CITY OF LA VISTA
MAYOR AND CITY COUNCIL REPORT
NOVEMBER 5, 2019 AGENDA

Subject:	Type:	Submitted By:
APPLICATION FOR PUD SITE PLAN – STRECK, INC, LOTS 1 & 16, HARRISON HILLS (S 118 TH ST & EMILINE ST)	◆ RESOLUTION ◆ ORDINANCE RECEIVE/FILE	CHRISTOPHER SOLBERG SENIOR PLANNER

RE: Planned Unit Development – Initial Review
Streck, Inc. – Harrison Hills

RE: Planned Unit Development – 2nd Review
Streck, Inc. – Harrison Hills

LEGEND

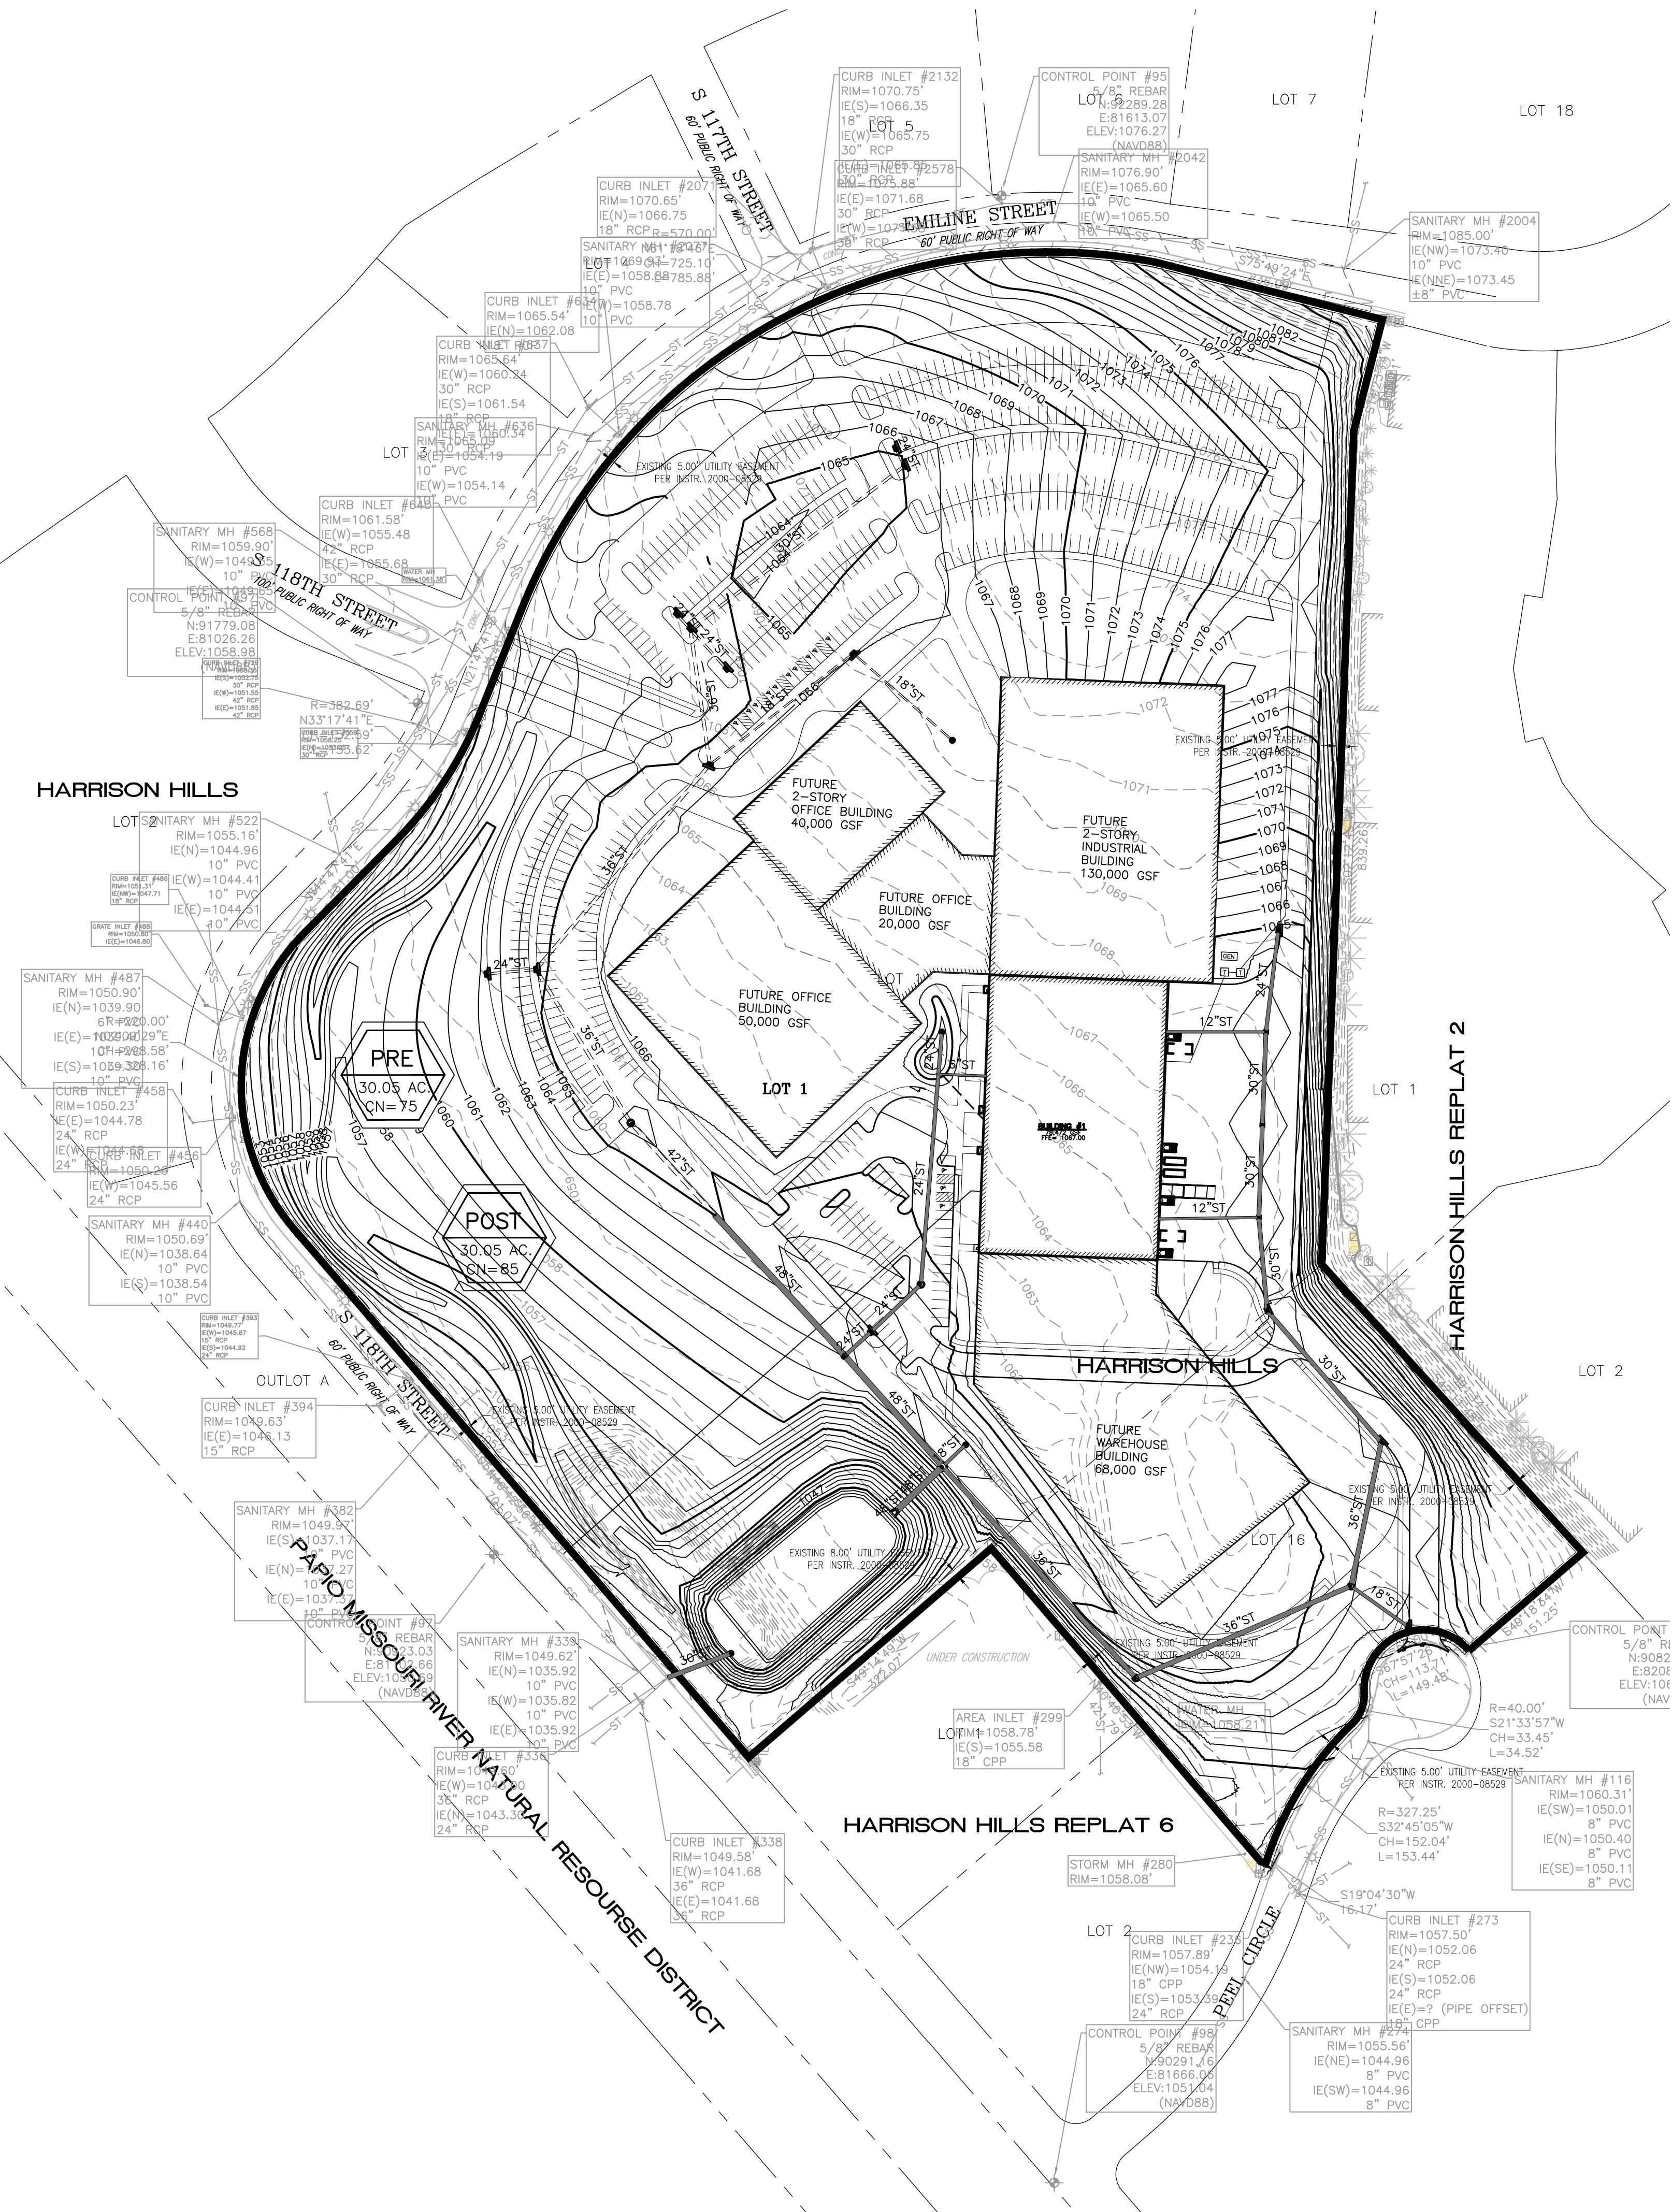
6. Comment Response #11 – Sanitary sewer connection fees and stormwater management fees were noted per the PUD Development Fee Table per the PUD Phasing Plan Exhibit, however the fee rates were not consistent with the current Master Fee Ordinance. Current Watershed Fees are \$4,963/acre (as of 7/1/19) and Sewer Connection Fees are \$7,407/platted acre (as of 1/1/2019).

Response: The PUD Development Fee Table has been updated per the 2019 fees listed above.
